TITLE: PUBLIC HEARING regarding a Vacation and Replat of Tract 16, The Horse

The Horse Creek Ranch, Third Filing
PZ-23-00018

First Review Combined Comments Report

AN ADMINISTRATIVE REPLAT OF TRACT 16, THE HORSE CREEK RANCH, SITUATE IN SECTION 34, T15N, R67W, OF THE 6TH P.M., LARAMIE COUNTY, WYOMING. PREPARED FEBRUARY 2023

Figure 2. HEC-RAS Model w/Base Flood and Encroachment (Floodway)

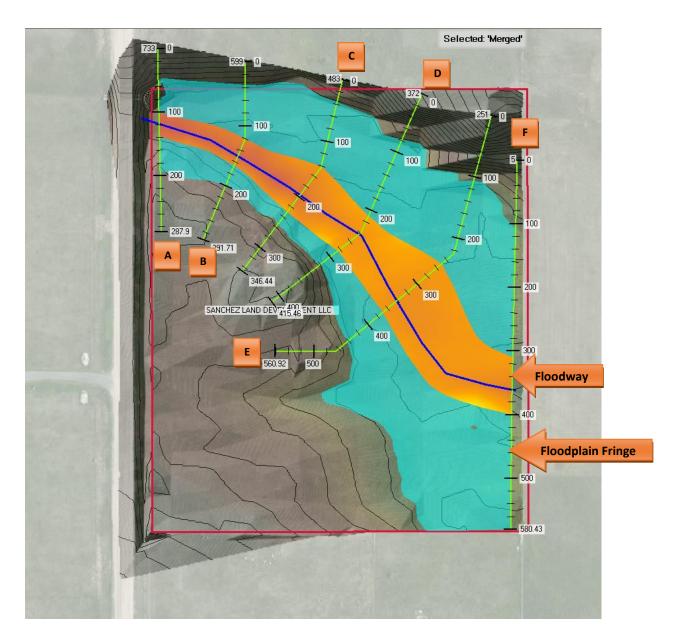
1. The letter report submitted by CivilWorx, on page 3 includes a figure (Figure 2) that labels a floodway and floodplain fringe. I believe it is incorrectly labeled as a floodway and needs to be changed. FEMA has not established a floodway within this floodplain and I do not believe the intent is to create one now. For the plat drawing, it should only show the newly established floodplain which is labeled on Figure 2 as the floodplain fringe and should not show and/or label what is currently referred to as the floodway. It is my understanding that the purpose of the area labeled as the floodway as the area no structures should encroach on in order to have no significant impact on the floodplain

and/or base flood elevation. The other area labeled as the floodplain fringe is an area that could potentially allow a structure and not significantly impact the floodplain or base flood elevation. The current plat also labels the Floodplain and Floodway incorrectly -- they should be reversed in order to line up with Figure 2. However, as previously mentioned, the plat should only show the floodplain area and the letter report should be modified to change the label and any reference to "floodway" to something else. Maybe it could be labeled as "no encroachment area" or something similar but not use FEMA terminology that contradicts existing FEMA designations for this floodplain area. This letter report will be important for any proposed structures within the newly designated floodplain area, which would still require a floodplain development permit application. A copy of this report should be included with any floodplain development application and/or building permit application to the County. Corrected

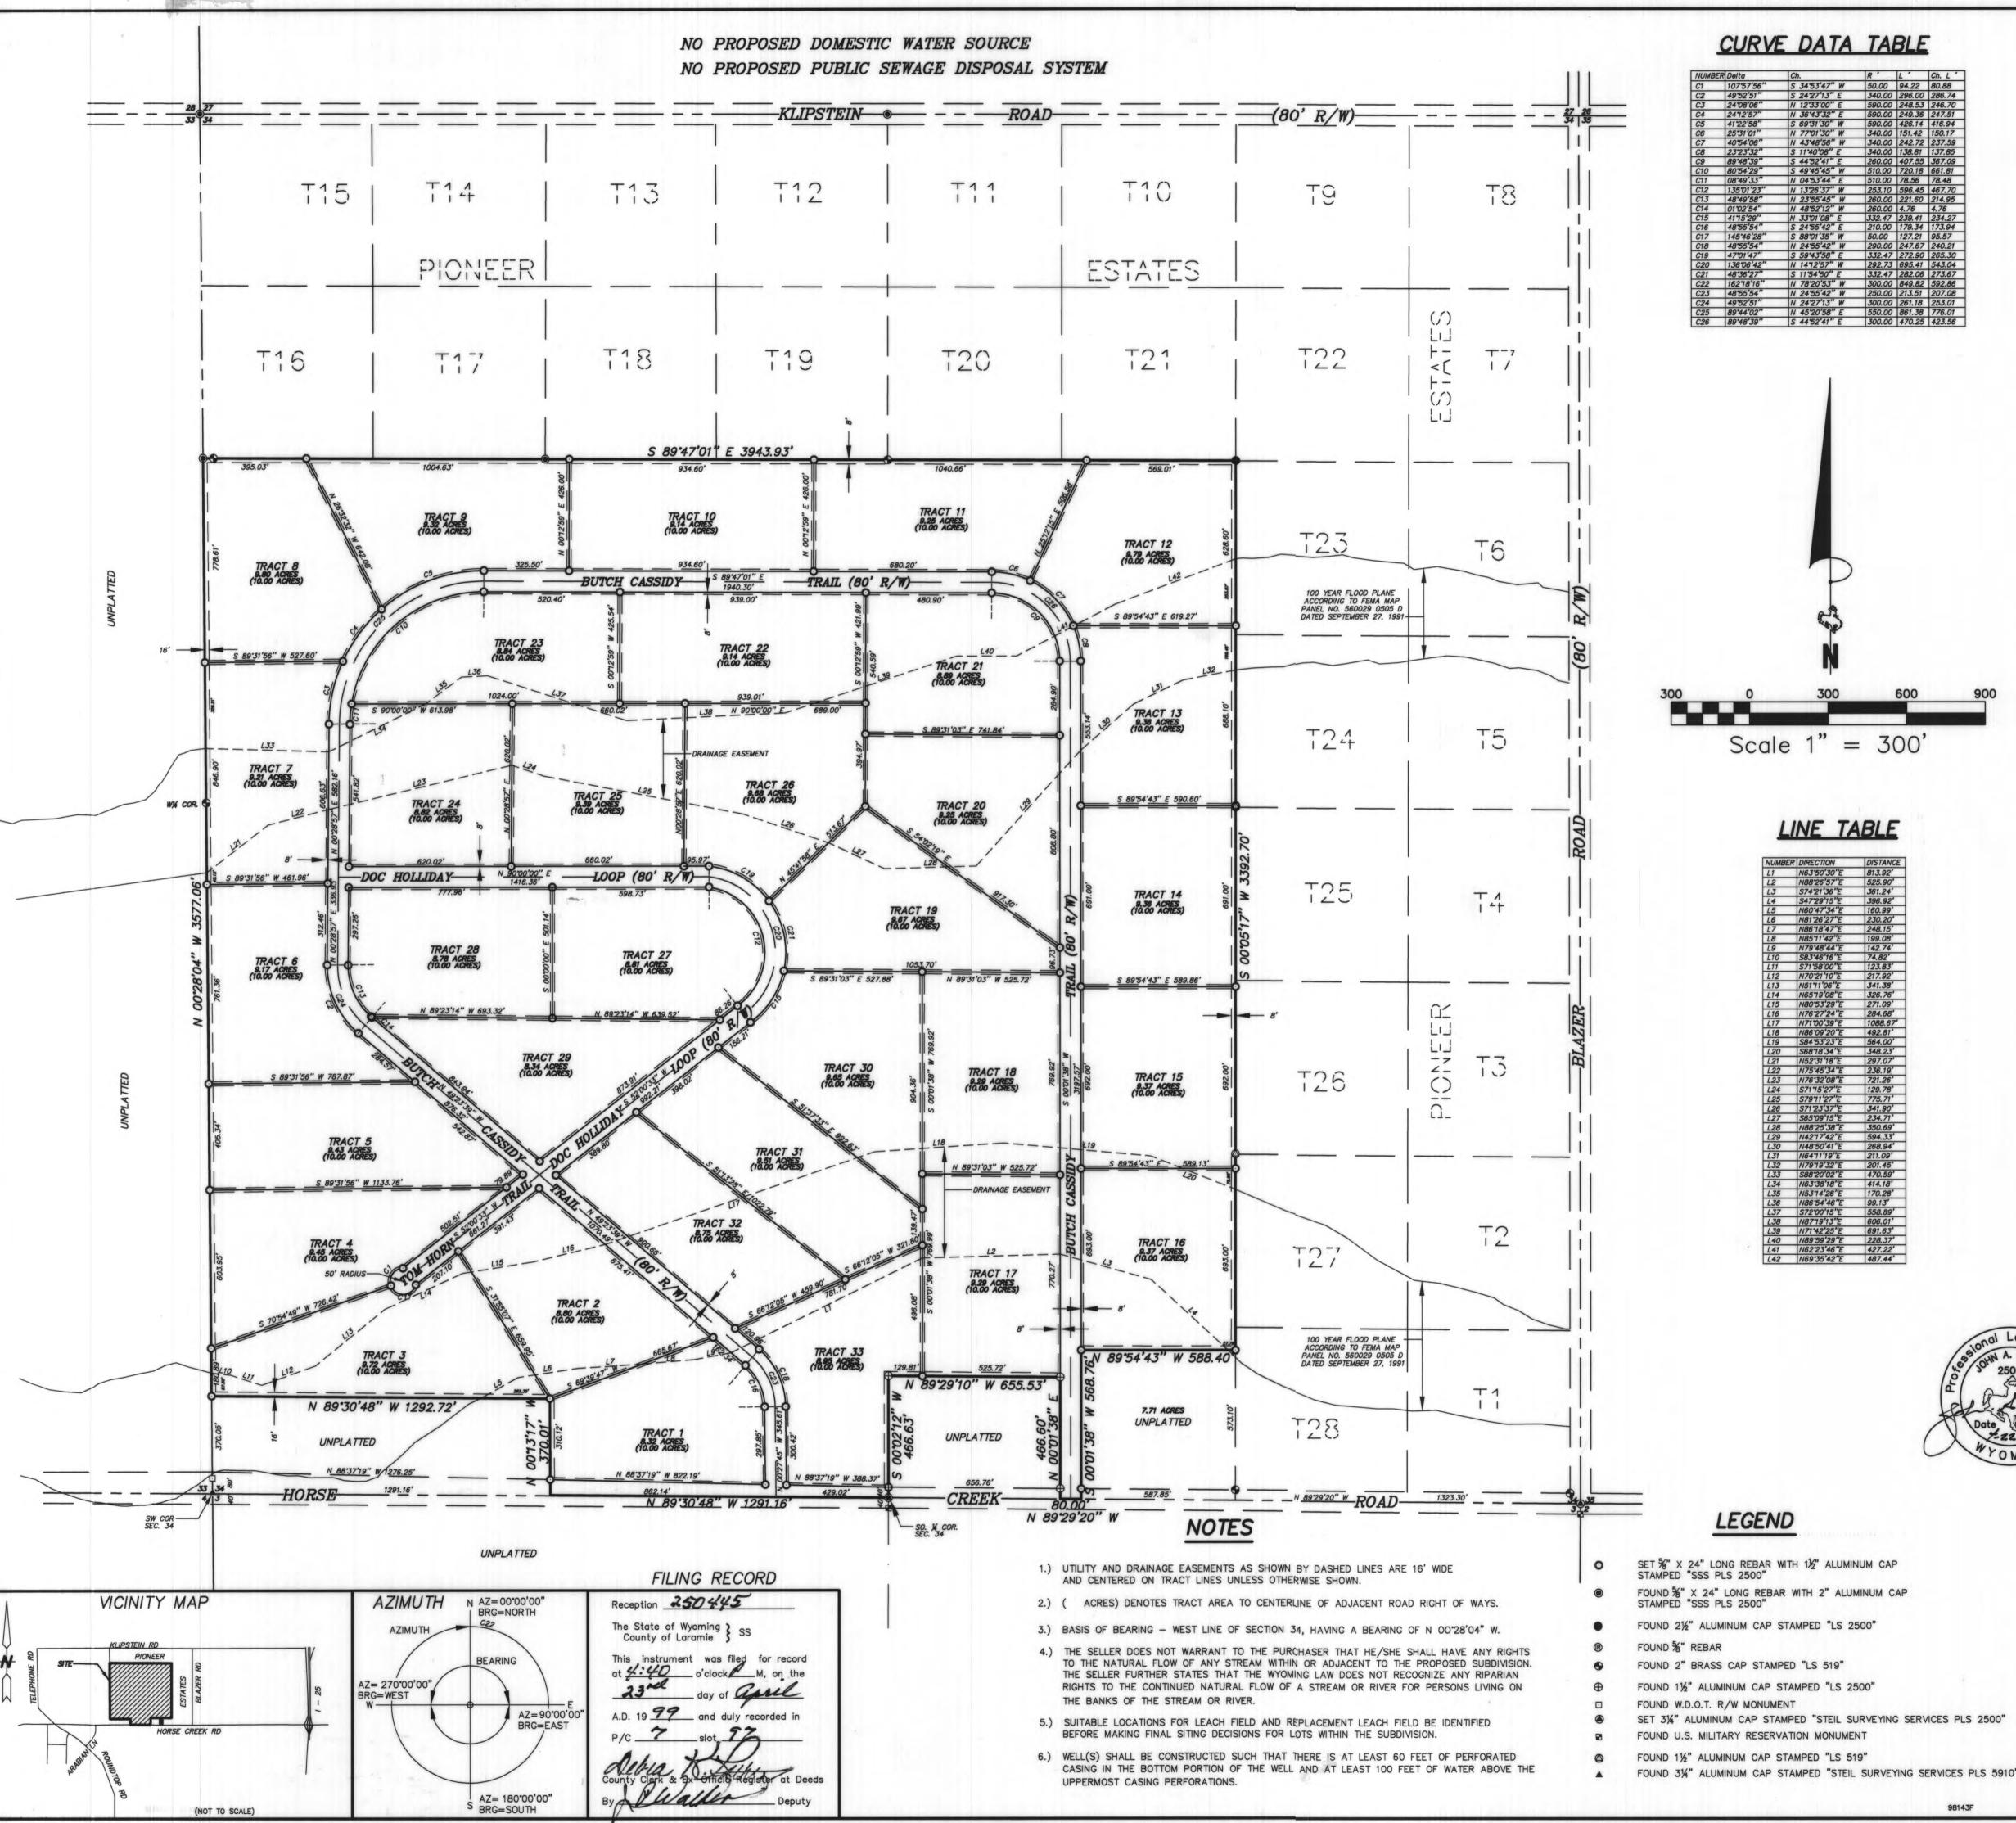
1. Acres or sq. ft will need to be labeled on the tract itself. Added

- 2. If it is the intent of the plat to create a new drainage easement following the newly established floodplain, a mete and bounds description (i.e. bearings, distances, curve data, etc.) of the new easement is required. It would be my suggestion that a new easement be established for the floodplain that generally follows the new floodplain boundary (similar to the existing drainage easement that is being vacated) instead of following it exactly due to all the bend, curves, etc. If the intent is to only create a drainage easement for the area that is currently labeled on Figure 2 as the floodway, then that needs to be clarified on the plat and in the letter report. The letter report should then clearly explain why the easement is not for the entire newly established floodplain. In either case, the proposed drainage easement needs to be clearly labeled on the plat drawing along with bearings and distances for the easement boundary. The easement is being vacated. There will not be a new easement. The easement was created by the floodplain on the original plat. An easement on a floodplain is not necessary.

- 3. The plat refers to the letter report prepared by CivilWorx and it refers to Kelley Hafner which should be spelled Kelly and not Kelley. Based on the statement on the plat, the report will need to be recorded with the plat since it refers to it on the plat. I assume the applicant plans on doing that but wanted to verify. We will record with plat

- 4. The plat title needs to include that it is an Administrative Plat and it needs to include the Township, Range, and Section. Added
- 5. The approvals are incorrect for an Administrative Plat. This is an administrative plat, however it requires board approval for vacation of the drainage easement.

- 7. Due to the various different line types illustrated and used on the plat drawing to designate various boundaries, it would be beneficial to add the line types to the Legend. Shown

- 1. The designation (LOT OR TRACT number) of the re-platted TRACT 16 is not shown on the plat. Added
- 2. The area (i.e. acreage/sq.ft.) of the re-platted TRACT 16 is not shown on the plat. added
- 3. Even though this subdivision is a re-plat of a portion of a previously platted subdivision and shows the roads in the immediate vicinity, the Vicinity Map would be more congruent with the Title Block requirements if one were to add information such as, at a minimum, the Section, Township and Range data with enough detail to indicate the location of the subdivision within the Section. Added

5. There is a label (DRAINAGE EASEMENT PER PLAT), shown just north of the northwest corner of this subdivision, that is not specifically connected to anything. The label is on the easement line shown
